SOUTHERN POWER DISTRIBUTION COMPANY OF TELANGANA LTD. Corporate Office, 6-1-50, Mint Compound :: Hyderabad-63

## BID No. Chief General Manager/Projects/TSSPDCL/AMR : 01/2023-24

## Corrigendum - 11 Amendment to bid

Proposed architecture for centrally located inverters and distributed inverters is attached for reference.

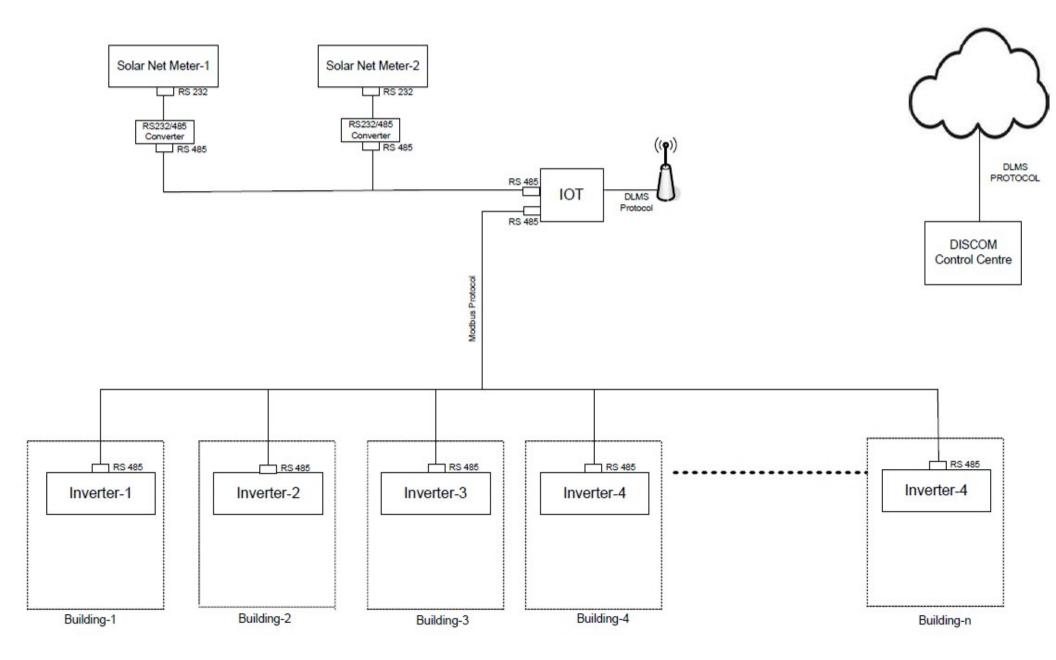
- IOT device shall have 2 or more RS485 Interfaces. One interface can be used for communicating to the energy meters in Modbus/DLMS protocol. Second RS485 interface shall be used for communicating with the Inverters in Modbus Protocol. Additional RS485 Interface as spare if required.

- If the Energy meters has RS232 Interface only, it shall be converted to RS485 interface using a converter and shall be connected to the IOT device.
- If the number of devices/ length of cable exceeds the MODBUS feasibility multiple IOTs/multiple Repeaters may be proposed as per site condition.

- Necessary converters as per requirement for connecting inverters/meters to IOT device shall also be included in the scope.
- If the existing RS 485 port of Inverter is in use by OEM for acquisition of inverter data, the same shall be disconnected and used for acquisition of Inverter data by appointed bidder (on behalf of DISCOM) and the generation data in turn may be provided by appointed bidder (on behalf of DISCOM) to Generator/OEM.

- 1. Real time Solar power generation data i.e., KW, KVAR to be integrated in AMR project along with Net meter data
- 2. Inverters data from OEM may be integrated to DISCOM for redundancy.
